As discussed during our September 15th public meeting, enclosed please find the Environmental Management Advisory Board EM Tank Waste Subcommittee Report for Waste Treatment Plant; Report Number EMAB EM-TWS WTP-001, September 30, 2010, in accordance with the Work Plan directive dated May 10, 2010. This report covers the work plan observations and recommendations concerning the Waste Treatment and Immobilization Plant at Hanford (WTP). The charge is summarized below.

EM Tank Waste Subcommittee Report for Waste Treatment Plant

Report Number EMAB EM-TWS WTP-001

September 30, 2010

Figure C-2. Comparisons of design wear allowances to the predicted 40-year wear (24590-WPT-RPT-PET-08-008, Rev. 0)

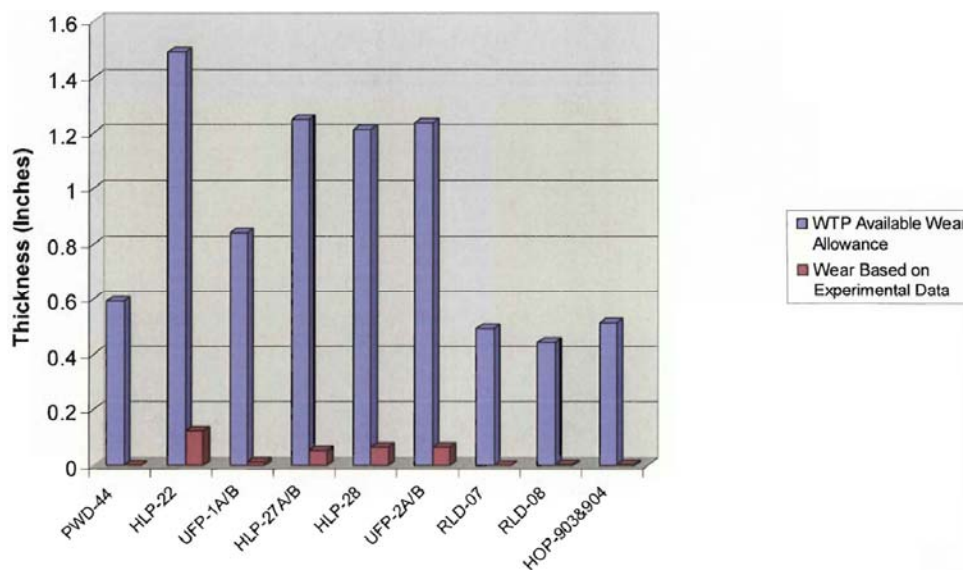
This issue was resolved by performing tests that verified that the curve used (Figure C-2) was a conservative estimate of erosion. Although run with simulants, these tests should provide a reasonable basis for closure of this issue. However, it was acknowledged that the largest particles cause the wear and the effect is highly non-linear (Page 6 of 24590-WPT-RPT-PET-08-008, Rev. 0), but only the weighted average particle size was used as the parameter to validate the test slurry. It appears that this had no significant effect since the wear curve used for design was still more conservative than that representing the largest particles used in these tests (54 microns).

The use of pre-qualification testing to characterize individual batches for erosion is a significant advantage to the program. Tests to determine the average weighed particle size of any incoming batch need to be conducted as part of this characterization program. The results of these tests can be turned into a running tally of expected wear in each tank based on the actual feed percentage and size.
